UNITED STATES ENVIRONMENTAL PROTECTION AGENCY

Re: Response to Comments to draft Operable Unit Two Remedial  
Action Work Plan; Ringwood Mines/Landfill Site

RE: Ringwood Superfund Site OU-2 RAWP  
Ringwood Environmental Commission Concerns on Response to RAWP Comments

TEST TRENCH 1 (TT01)  
CROSS SECTION (A - A')

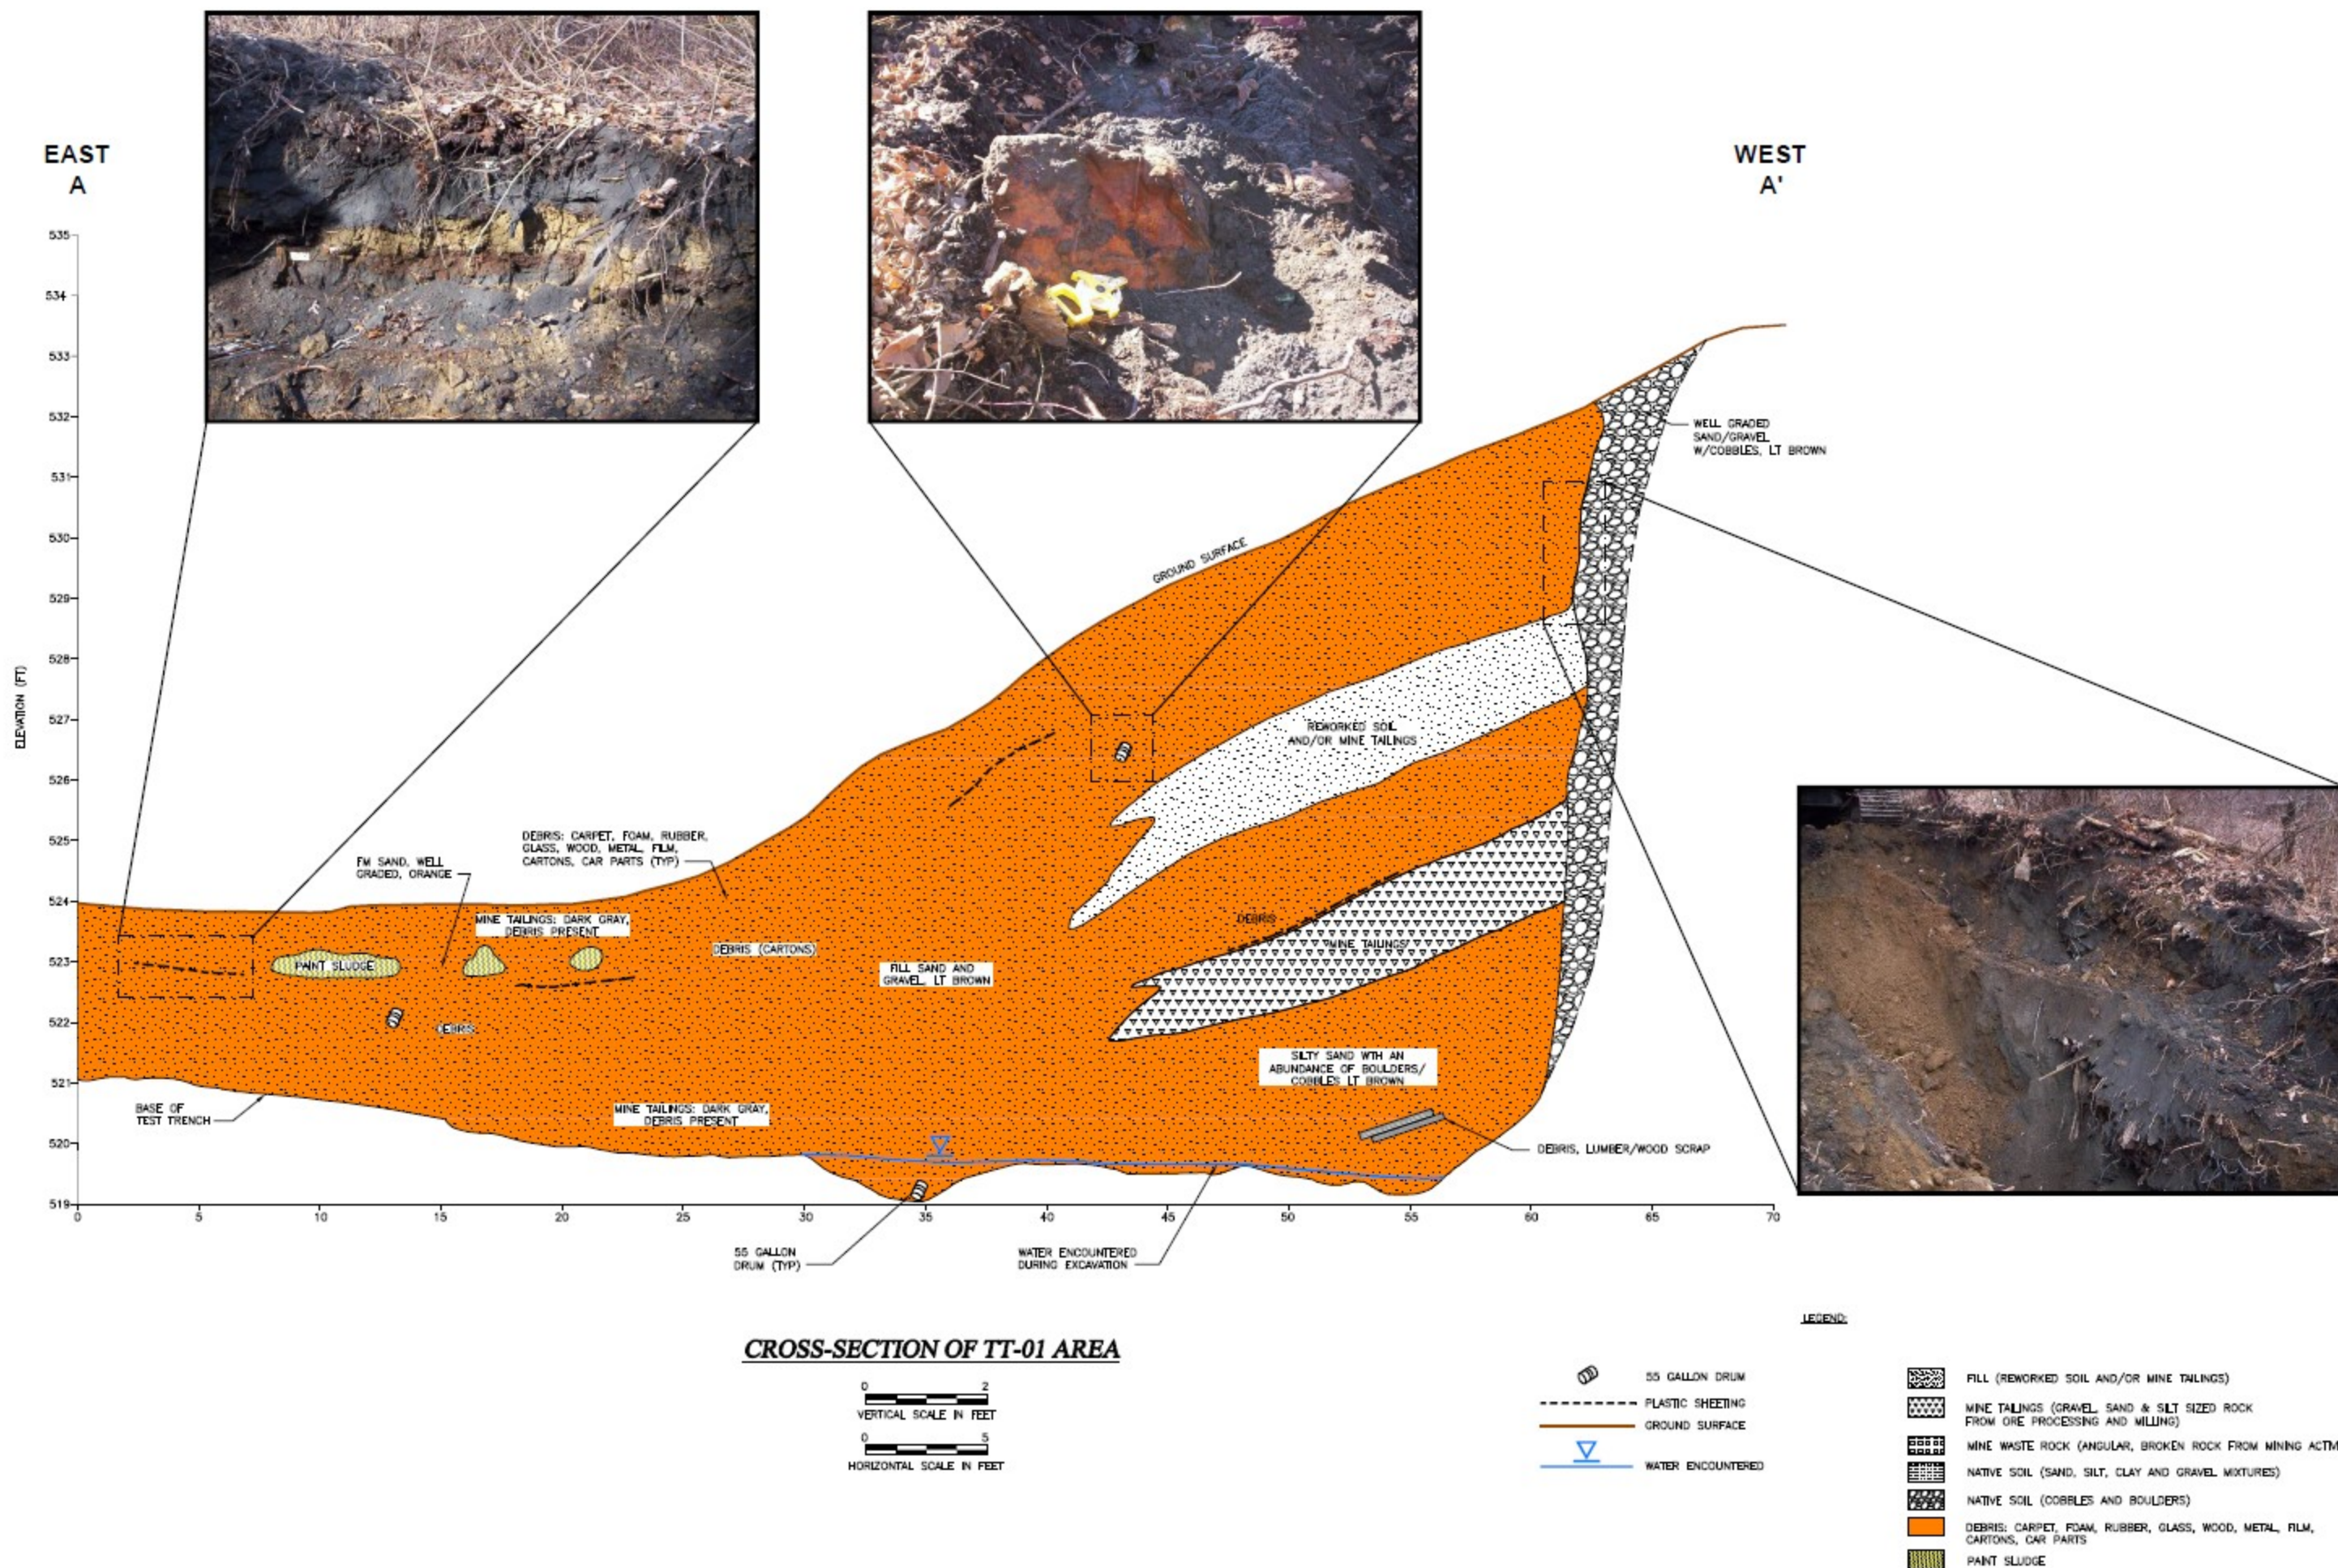
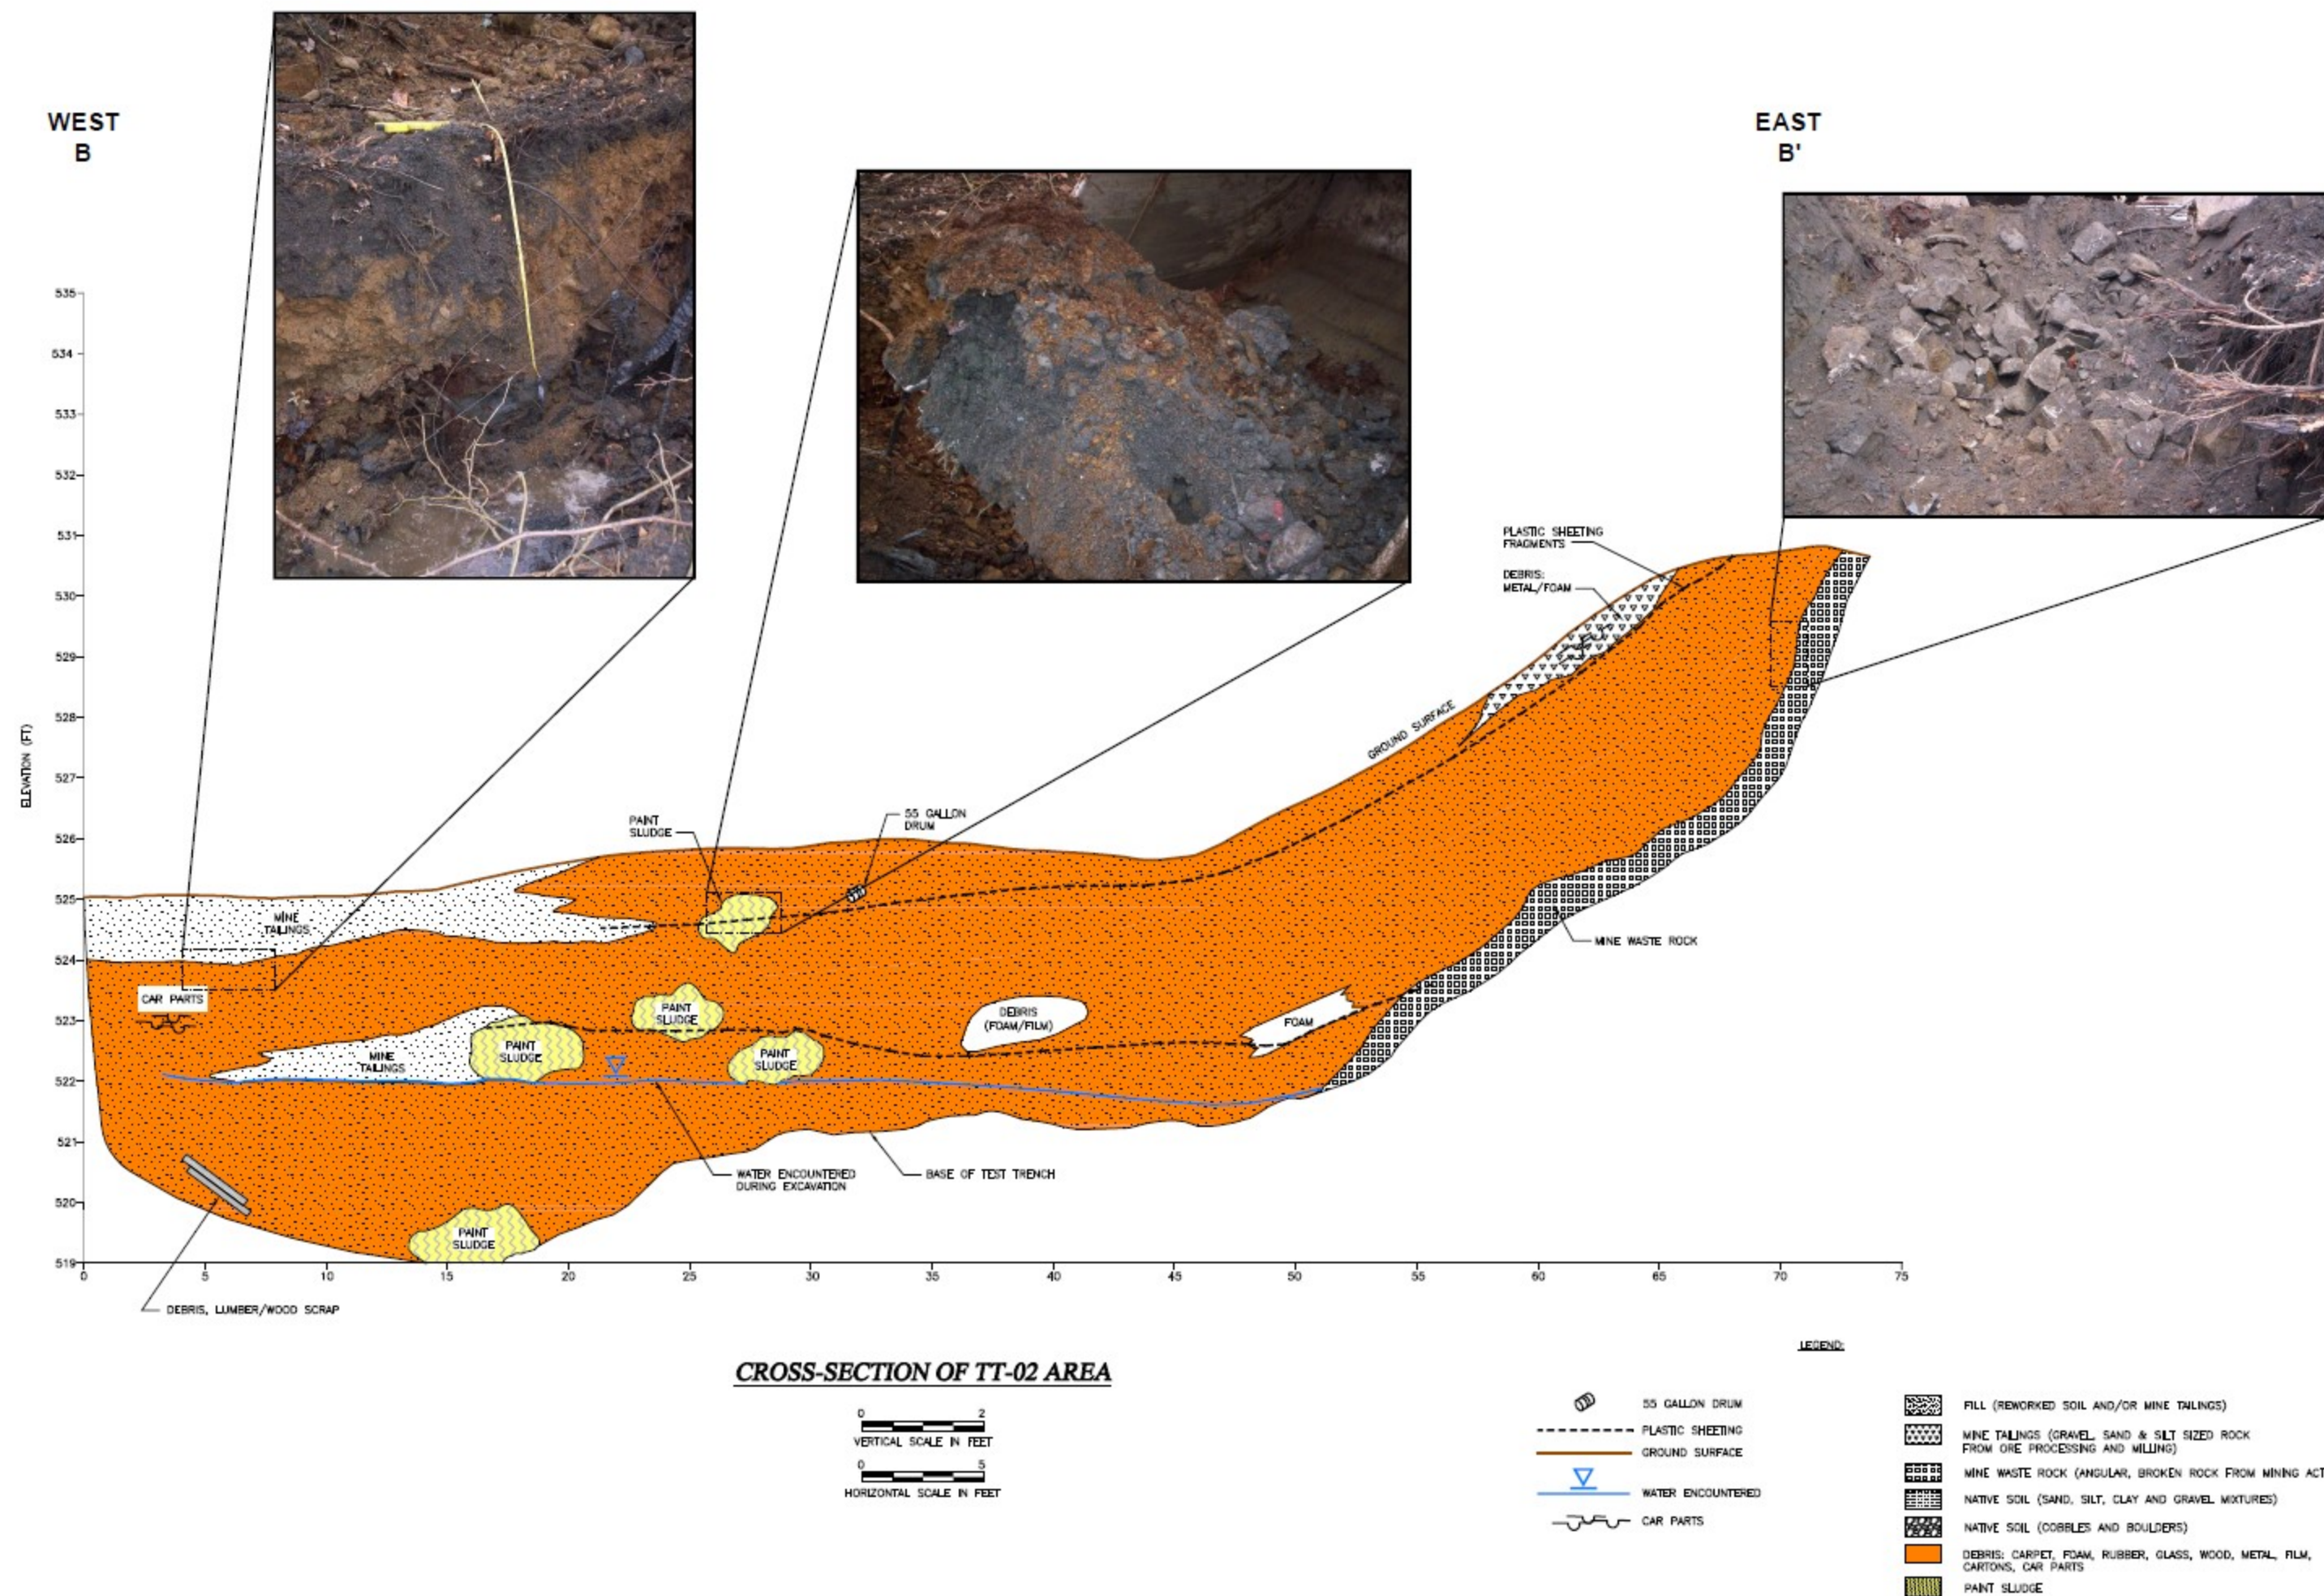
1. The Arcadis drawings from 2009 clearly indicate drums and paint sludge located beneath the waterline. We do not believe any action was taken to remediate this since that report came out. We have attached the images from the report. Please amend your response to remove the uncertainty in it. There are known drums and paint sludge below the waterline and the response should not falsely claim that there may be none. This is a known fact.

2. You should definitely anticipate moving a larger volume of water than can simply be pumped out at the site. When this water is brought up from the ground it is critical that the responses to section 1, security, also be addressed by doing everything possible to prevent humans from coming into contact with this water. Please include a plan for having to move the additional water that you are not anticipating or explain why the attached drawings are not taken into consideration.
